SERVICE BULLETIN

M-1255

2009 AND 2010 SOFTAIL FUEL LINE AND SPARK PLUG ROUTING

Figure 1. Correct Spark Plug Routing

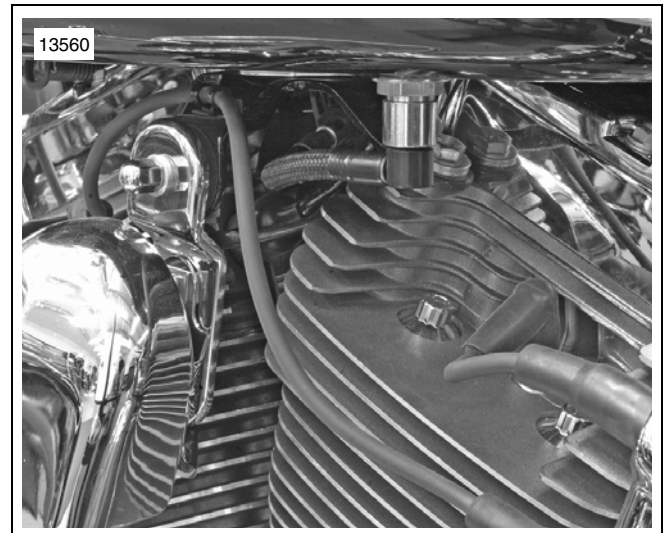
1. See Figure 1. Check spark plug routing near fuel line. Make sure front spark plug wire is routed on outside of fuel line and that they are not touching.
2. If spark plug wire is incorrectly positioned, re-position spark plug wire as needed.
